Service Bulletin

Title: **Cylinder Barrel Fillet Inspection**

SB No.: **10-11**

Figure 2: Drawing showing an unacceptable barrel fillet.

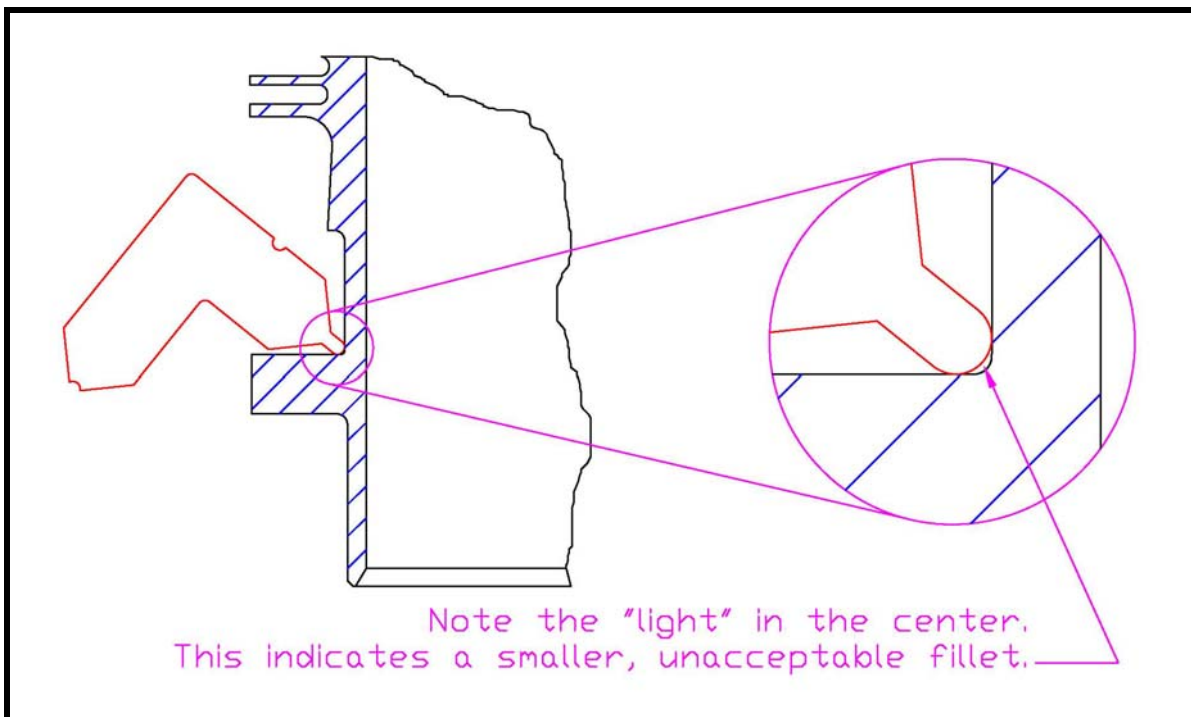
5. Using the .040 radius gage provided, visually inspect to ensure the fillet is correct as shown in Figure 2 and Photographs 2, and 3.
6. This inspection need only be accomplished at one point on the flange as the fillet will be consistent throughout the manufacture of a single barrel. If the fillet is too small, the cylinder must be removed from service. If the fillet radius is at least .040, then no further action is required. Annotate the engine logs that ECi SB 10-11 has been complied with.

7. For those cylinders found to exhibit a fillet less than .040, remove and return to ECi for a replacement cylinder. Please contact ECi Customer Service at 800-ECi-2Fly (800-324-2359) for further information.

Photograph 2:

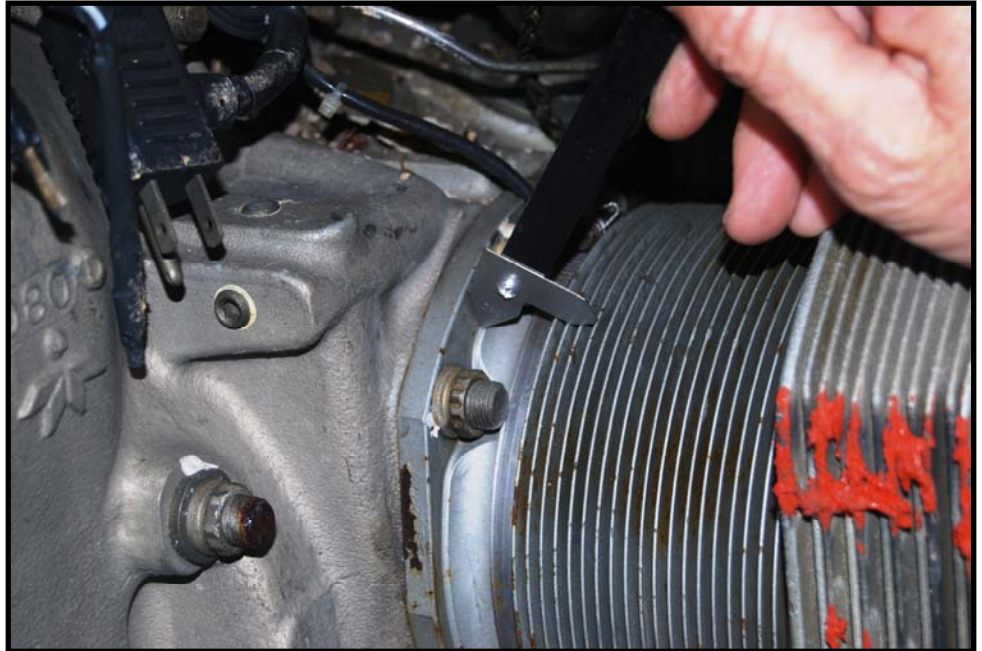
Radius gage attached to an extension to aid in the inspection. This photograph shows an acceptable fillet.
